ADDENDUM AND REVISION #02

Project Name: Mt. Olive Church Addition/Remodeling
2460 Mt. Olive Drive
Suamico, WI

Architect Project Number: G-216667

Date of Addendum: June 7, 2017

12/A202 ENLARGED TOILET ROOM PLANS
SCALE 1/4" = 1'-0" w/ ACCESSORY TAGS

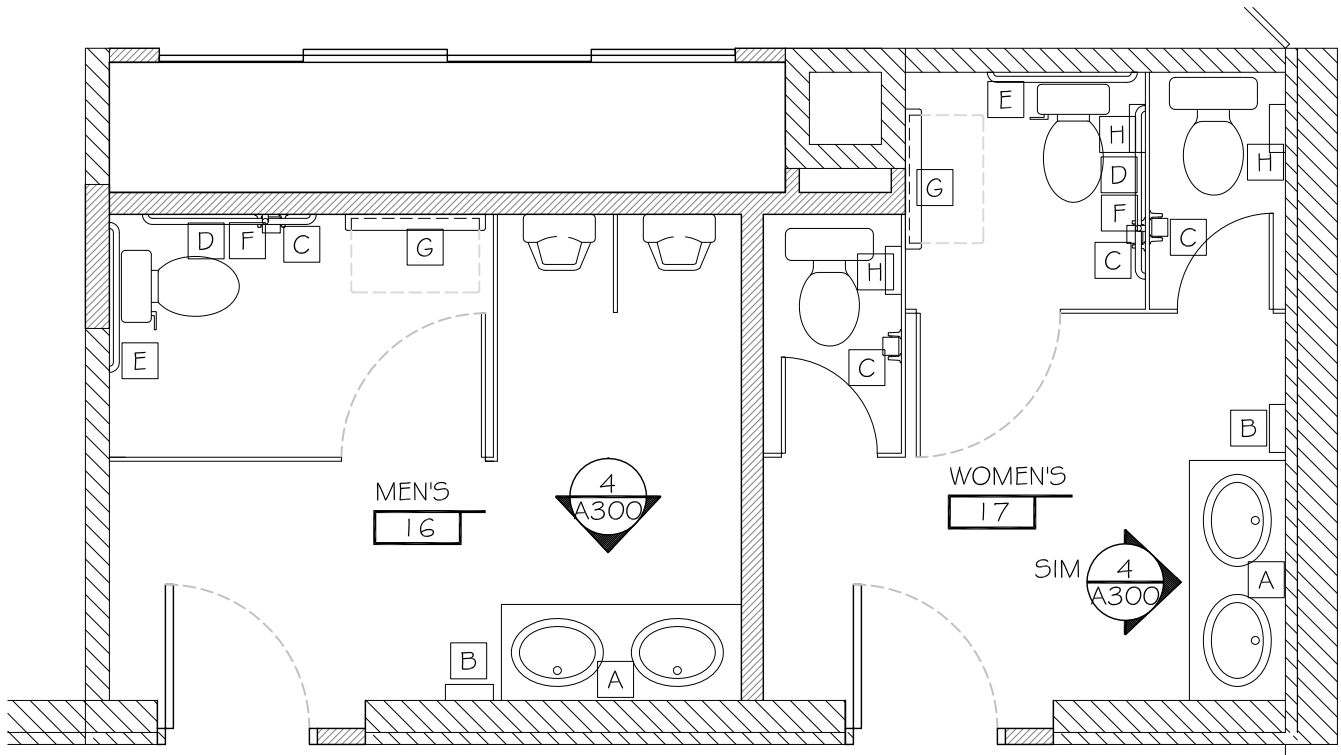
1. Document 00 41 13.1 REVISED BID FORM dated June 7, 2017
2. Drawing ADD.2 Enlarged Toilet Room dated June 7, 2017
3. Light fixture package from Spectrum Lighting.
4. General Contractors List from Dimension IV dated June 7, 2017
5. Plan Holders/Activity List from Blue Print Services dated June 7, 2017
